6<sup>th</sup> EGM (21.11.2008)

Leopard enclosure

Tata Steel Zoological Park

DESIGN FOR LEOPARD ENCLOSURE (NEW)

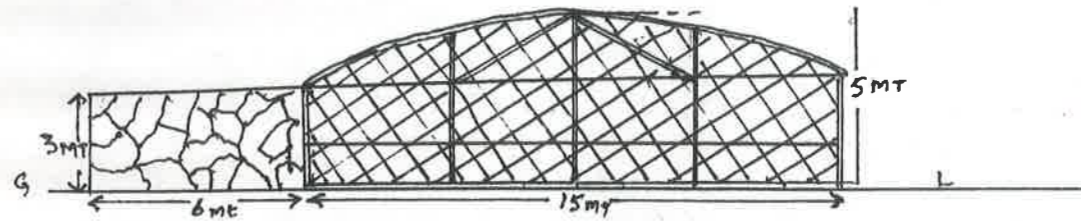
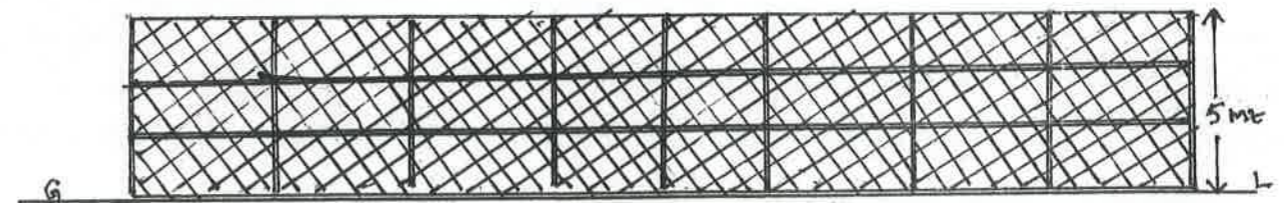
Approved subject to:

1. The display area for leopard should be of atleast 600 sq. meters.
2. However, the members desired that the isolation ward for leopard may consist of two feeding cubicles with in built squeeze cage with a small keeper's gallery and a covered kraal like a structure of 15X15 meters in size (250 sq. meters).
